DEFENSE NUCLEAR FACILITIES SAFETY BOARD

November 2, 1999

Staff Issue Report

SUBJECT: Review of Building 3019 Ventilation Systems Required for Safe Uranium-233 Operations and Long-Term Storage

RDF VENTILATION SYSTEMS

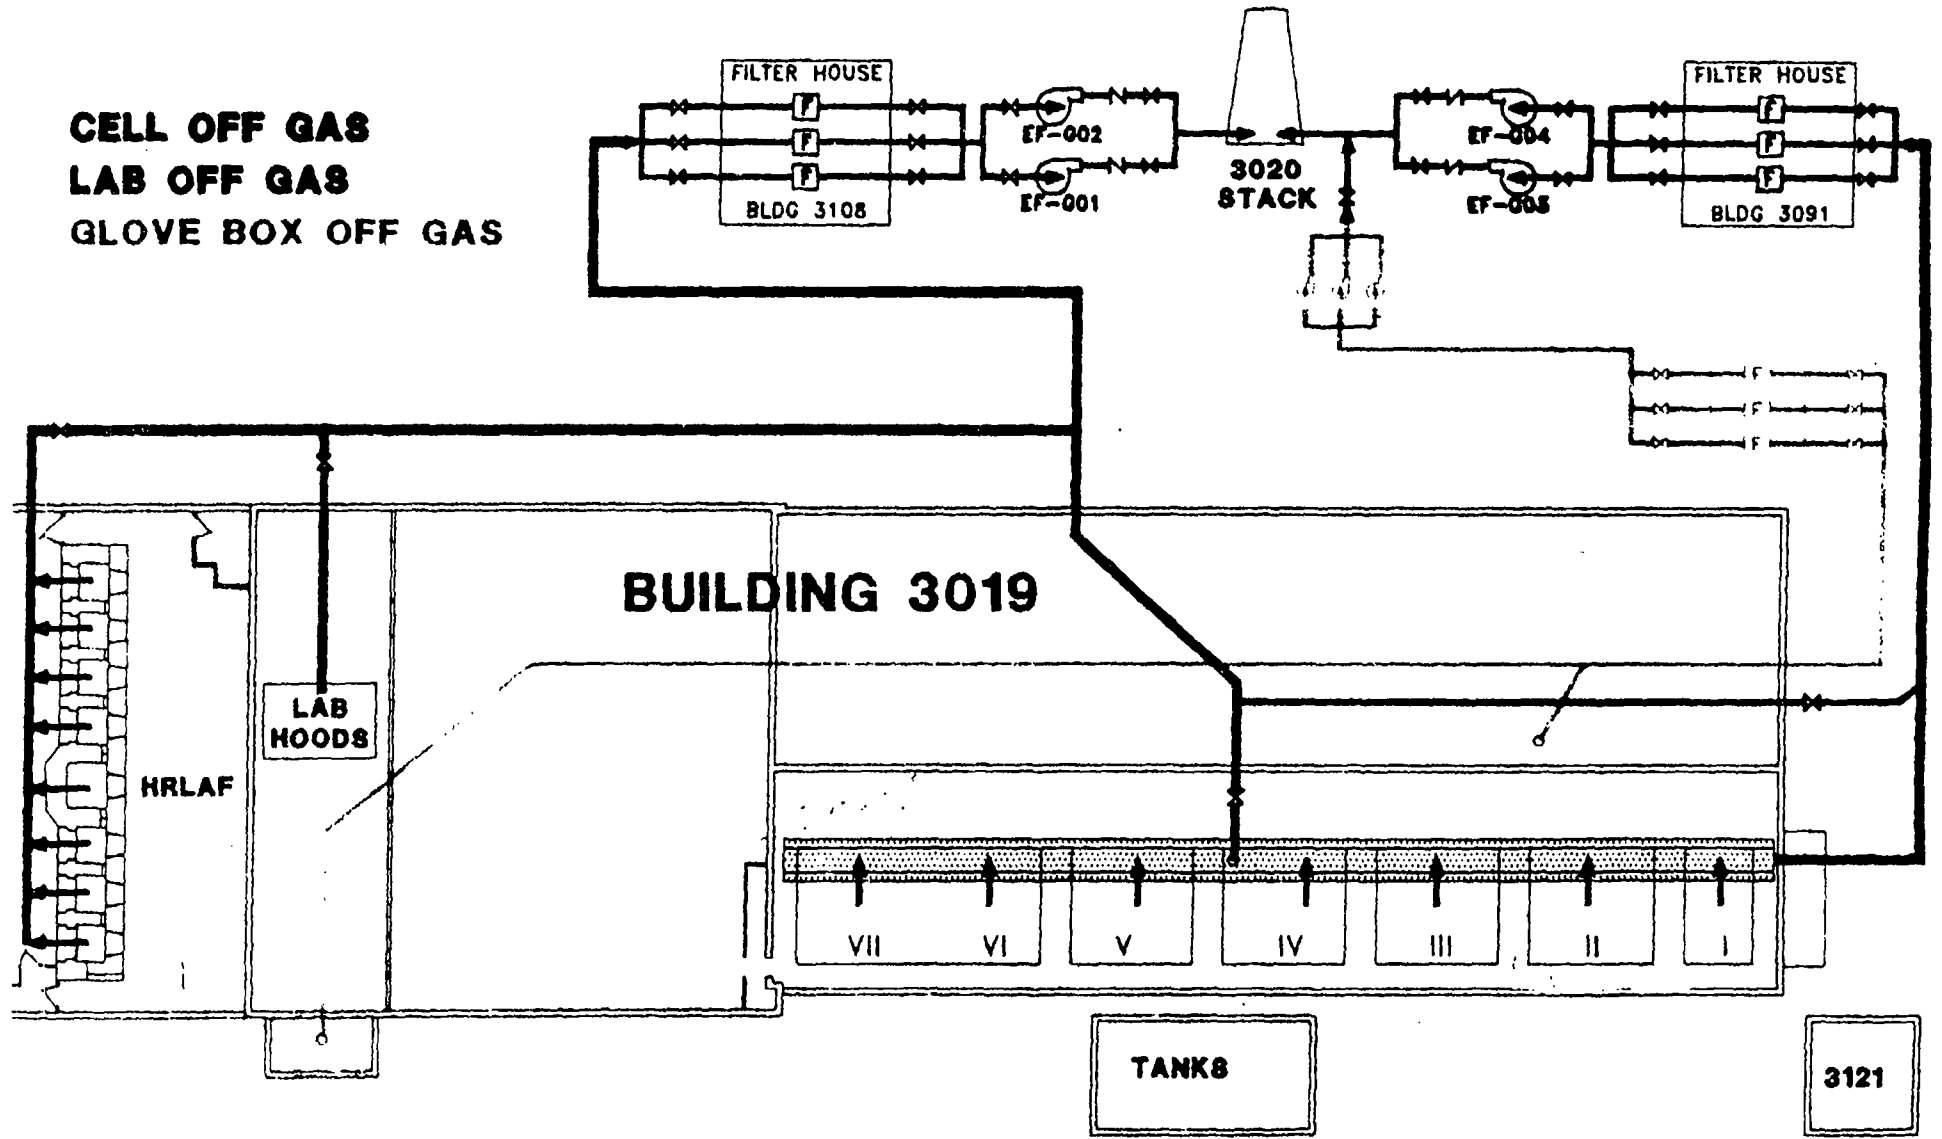
Discussion. Four off-gas systems ventilate Building 3019 (see attached diagram): (1) the Laboratory Off-Gas system (LOG), (2) the Cell Off-Gas system (COG), (3) the Glove Box Off-Gas system, and (4) the Vessel Off-Gas system (VOG). Most of these systems normally exhaust to the 3020 stack, the principal release point for the building. The primary ventilation system serving the uranium-233 inspection and storage areas is the VOG. Unlike the other

Building 3019 ventilation systems, the VOG usually exhausts through stack 3039. The VOG cross-connects to the COG and can therefore exhaust to either the 3020 or the 3039 stack. Further complicating the situation, the LOG can also be aligned to the COG.

The VOG system provides containment for any contamination released from the storage vaults. During certain operations involving movement of containers from the vaults, it is possible for a breached container to contaminate considerable lengths of the VOG ductwork because no filtration is provided near the point of potential release. The VOG exhausts through a filter at the 3039 stack, which is located approximately 100 yards away down a hill from Building 3019. Portions of the outside VOG lines are unshielded, and operations at the 3039 stack are under the purview of the waste management contractor. This situation can represent a potential hazard to nearby workers.

Finally, the lack of filtration close to the source of potential contamination releases in the VOG system may pose an unreviewed worker exposure issue. The staff believes selected compensatory measures (e.g., prefilters in the inspection chamber) are necessary for the VOG system prior to initiation of uranium-233 operations.
